Ref: 0536r01v03

**RE: 18 – 20 THE SERPENTINE, BILGOLA BEACH
DEVELOPMENT APPLICATION FOR THE CONSTRUCTION OF A STUDIO AND CAR PARKING STRUCTURE
PARKING DESIGN STATEMENT**

A Pre-lodgement meeting (ref: PLM 2021 / 0305) was held on the 09/12/2021 between the Applicant and Council's representatives with a number of aspects discussed relating to the Proposal including parking design. Council's comments are reproduced below, which are highlighted, for reference.

SECTION A

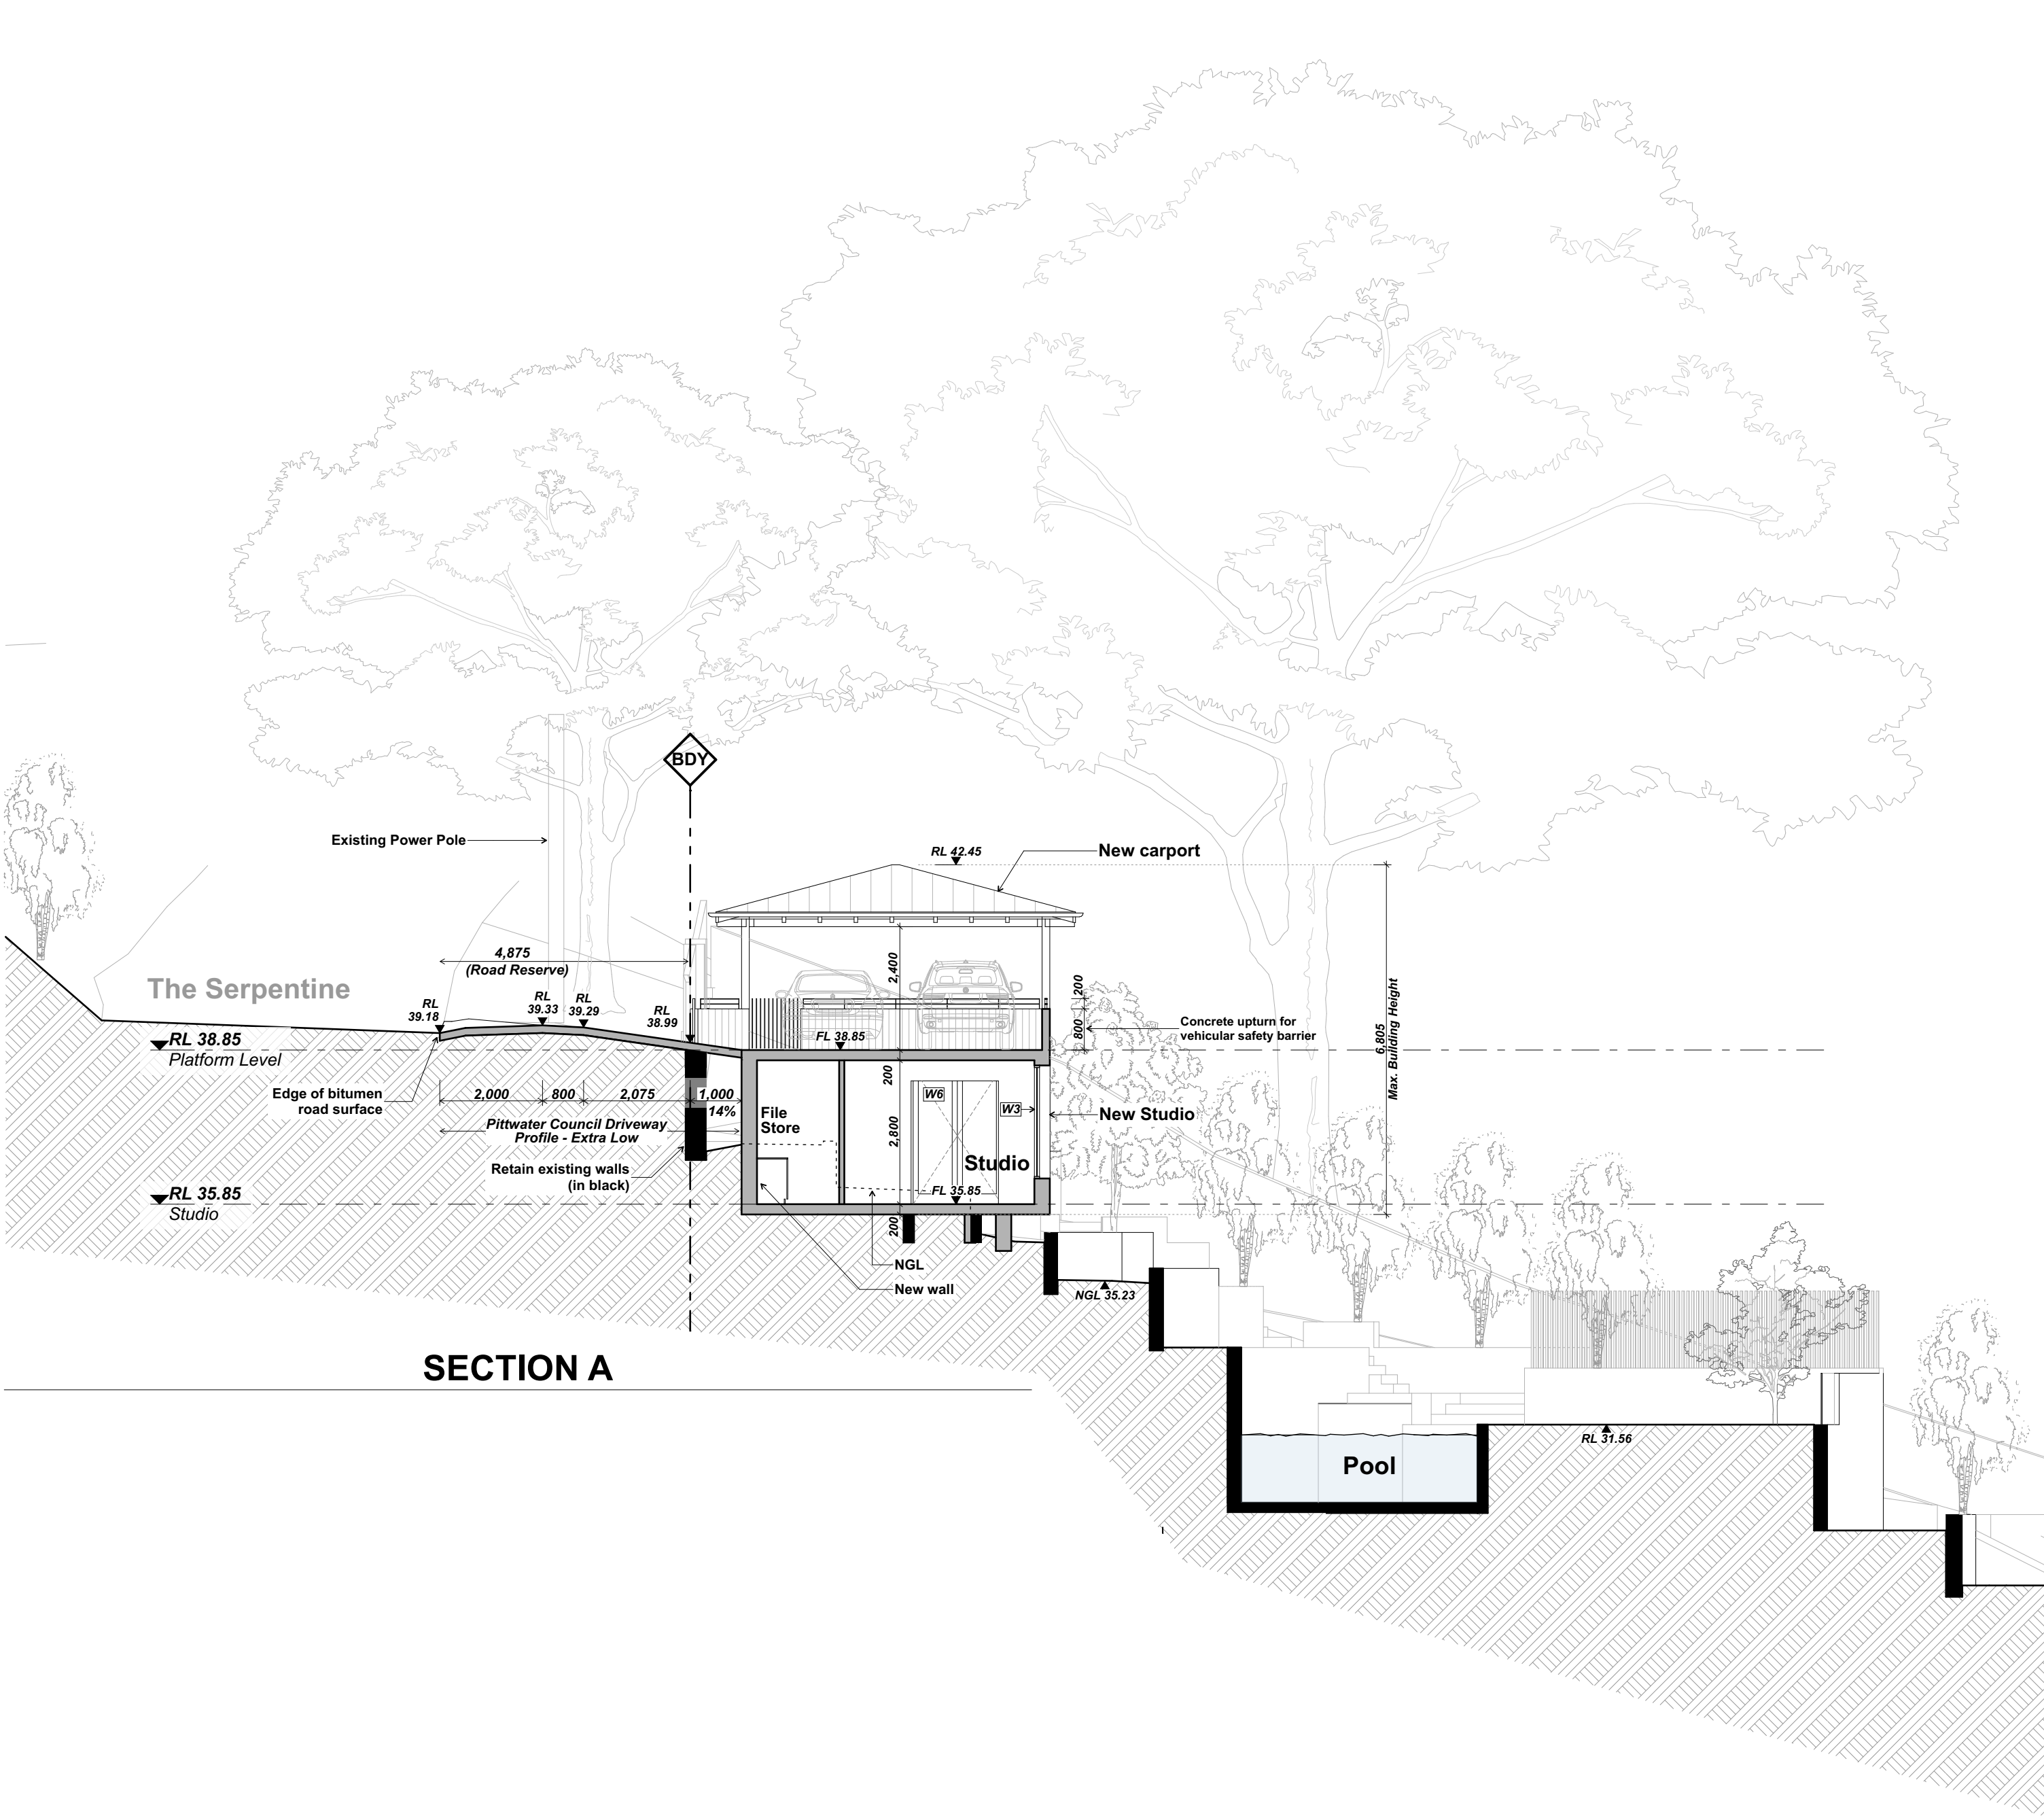
3. The driveway grades must be in accordance with Council's standard drawing A4/330/3 NL. Sections through the proposed crossing are to be submitted demonstrating compliance. The 1:4 Max grade shown on the submitted drawings must include a transition in accordance with the above standard drawing. This will require the proposed parking area to be raised to suit.

5. The proposed off-street parking is to be in accordance with Pittwater Council's Pittwater 21 DCP 2014 Clause B6.3 Off-Street Vehicle Parking Requirements.

- The driveway has a maximum grade of 1 in 7.1 (14%) and therefore satisfies the ramp and driveway grade requirements of AS 2890.1. The maximum grade transition is a sag transition of 1 in 7.1 (14%) which satisfies the requirements of Clause 2.5.3.(d) of AS2890.1.

- The car parking spaces are provided in the form of a double vehicle carport, having an opening width of 5.7 metres, an internal width of 5.7 metres and internal length of 5.7 metres, therefore complying with the relevant requirements of Clause 5.4 of AS 2890.1.

- The proposed double carport is provided with a minimum clear head height of 2.4 metres with satisfies the requirements of Clause 5.3.1 of AS 2890.1.
- A mechanical vehicle turntable is provided in front of the proposed double carport to assist manoeuvrability, given the narrow internal dimension of the car platform. The turntable ensures all vehicles can enter and exit the site in a forward direction.

- The turntables allow for a 6.0 metre clearance diameter and can accommodate vehicles up to a B99 Design Vehicle of length 5.2 metres, per Appendix A of AS 2890.1.. The internal diameter of the turntable itself will be dependent on the product selected by the client however, it is expected to be in the order of 4.8 metres.

- As shown by the architectural drawings included as **Attachment 1**, barriers are provided along the perimeter of the car parking platform. The barriers would not have any impact on driver's sight line to the northeast and to the southwest.

Attachment 3

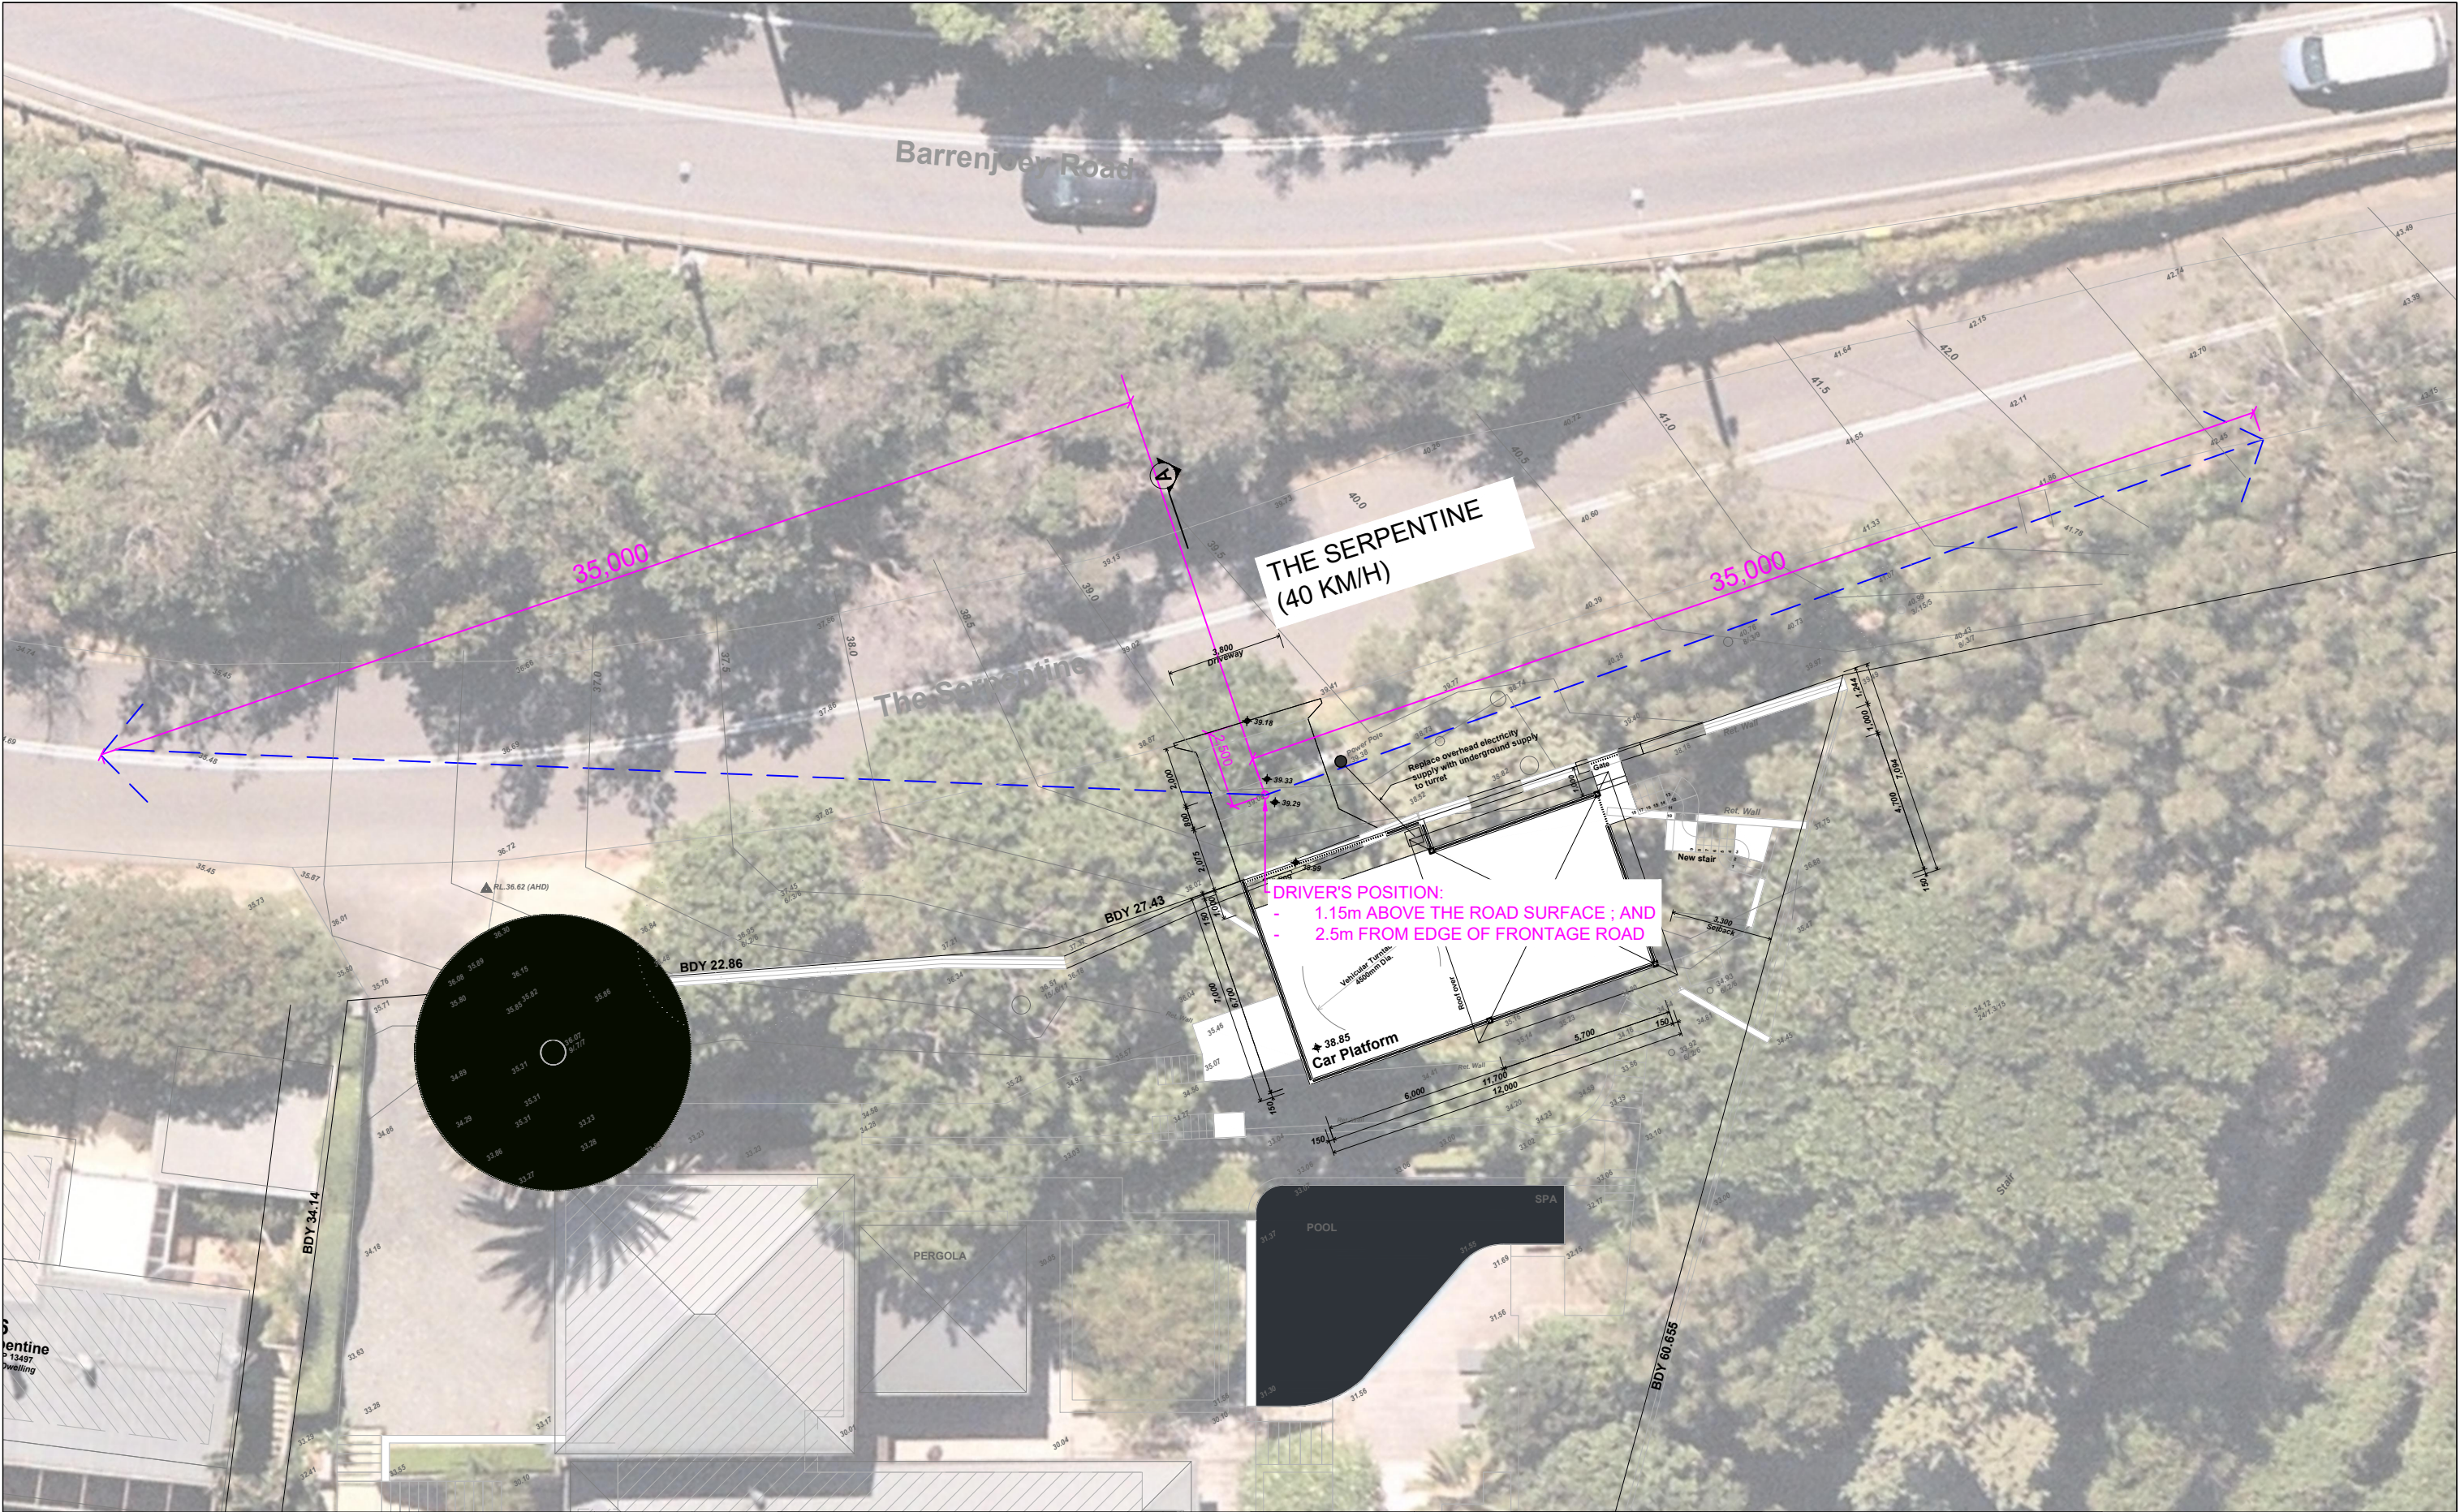
The applicant is to provide a site line analysis to address traffic safety for the proposal given the proximity to the road bend. Should the site line analysis recommend additional tree removal, the arborist report must take this into consideration. Please refer to Council's landscape officer comments regarding tree removal in the Council reserve.

2. The proposed driveway crossing, and internal driveway is to be designed in accordance with Pittwater 21 DCP 2014 Clause B6.1 Access Driveways and Works on the Public Road Reserve and B6.2 Internal Driveways. In this regard, the applicant must provide a Traffic Engineer's report to assess the sight distance requirements of the above DCP controls and AS/NZS 2890.1:2004. Where the sight distances required cannot be achieved, the proposal will not be supported.

Based on the posted speed limit of 40km/h along The Serpentine, a stopping sight distance (SSD) requirement of 35 metres would be required to the northeast and southwest of the proposed driveway. Reference should be to the Sight Distance Diagram included as **Attachment 3** which illustrate the Proposal will achieve the following sight distances:

- To the northeast: The Proposal achieves a sight distance of 35 metres, measured to the kerbside of The Serpentine
- To the southwest: The Proposal achieves a sight distance in excess of 35 metres, measured to the centreline of The Serpentine.

Having regard for the above, the Proposal therefore achieves compliant approach sight distances to both the northeast and southwest along The Serpentine.
